# Safety Evaluation Report

Related to the License Renewal  
of the R.E. Ginna Nuclear Power Plant

Docket No. 50-244

Rochester Gas & Electric Corporation

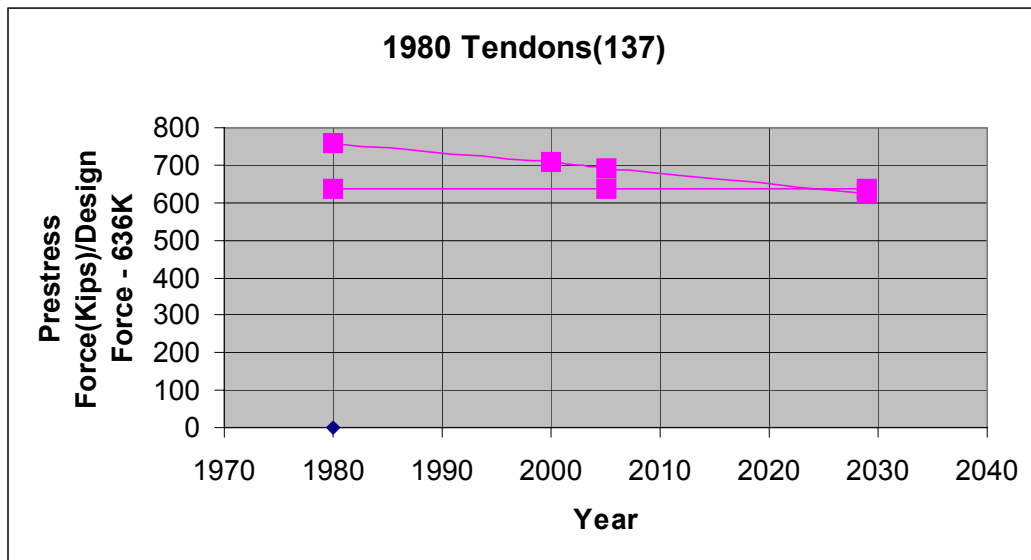
In addition to the review of Section 4.5 of the LRA, the staff reviewed the relevant information in Sections 2.4.1, 3.6, B2.1.3, B3.3, and Section 4.7.4 of the LRA. In the earlier years (1979–1980), the applicant had experienced lower prestressing forces than the minimum required value (MRV) estimated at 40 years. In order to understand the present state of the prestressing forces in the Ginna containment, the staff requested that the applicant provide the following additional information in RAI 4.5-1:

1. For the 137 tendons which were retensioned in 1980, the applicant was requested to provide the predicted lower limit line, MRV expected in 2005 and at 60 years (if not retensioned in 2005), a trend line for this group of tendons, and prestressing force values as points above and below the trend line measured during prior inspections.
2. The applicant was requested to provide the same information for the remaining 23 tendons for the inspections performed after the 1969 retensioning.

In response, the applicant provided the following information:

- a) Based on the available test information for this set of 137 tendons that were retensioned in 1980, the below graph shows the trend line from 1980 projected through 2005, and out to 2029. The graph also includes a constant line at 636 kips, which is the minimum design prestress force.
